STAFF REPORT: 02/08/2023 MEETING
APPLICATION NUMBER: 23-8205
ADDRESS: 100 LONGFELLOW STREET
HISTORIC DISTRICT: BOSTON-EDISON HISTORIC DISTRICT
APPLICANT: RANDY WHITE
PROPERTY OWNER: BRANDI BROWN
DATE OF PROVISIONALLY COMPLETE APPLICATION: 12/20/2022
DATE OF STAFF SITE VISIT: 01/24/2023

SCOPE: RENOVATE FRONT PORCH AND WALKWAY, REPLACE LANDSCAPING, REPAINT EXTERIOR

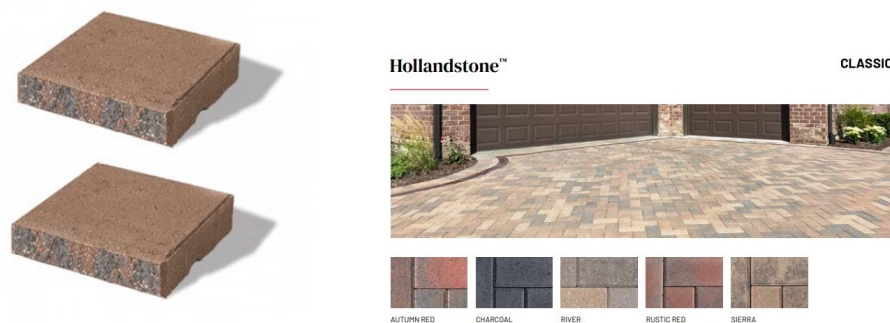
- The current paving material is tinted concrete, which differs significantly from the historically appropriate paving materials. The installed concrete pavers are darker in color and of a different texture and finish than the approved vitrified clay brick. A distinct gray accent course runs around the borders of the walkways and porch, while the historic paving schemes were uniform in color. Historic photographs show the original concrete stairs, as well as the 1981 brick stairs, were rectilinear in plan while the installed concrete pavers stairs are curved. Accent lighting on the stairs adds to the historic incompatibility. It is staff’s opinion that the current paving plan presents a decidedly contemporary aesthetic that is not compatible with the historic architecture of the property or the Boston-Edison Historic District.

- It is staff's opinion that replacing the concrete pavers with either a poured concrete (original material), or traditional red-brown common brick (as prescribed in the 1981 COA) paving scheme would meet the Secretary of Interior Standards for Rehabilitation and the Elements of Design for district.

It is staff's opinion the proposed concrete pavers and accent lighting and will significantly alter the features and spaces that characterize the property. Staff therefore recommends the Commission issue a Denial for the work as proposed because it does not meet the Secretary of the Interior Standards for Rehabilitation and the Elements of Design for the district, specifically Standards:

For the reason that: The proposed (installed) paving at the front porch and walkway is incompatible aesthetically and materially with the historic architecture of the dwelling and the Boston-Edison historic district.
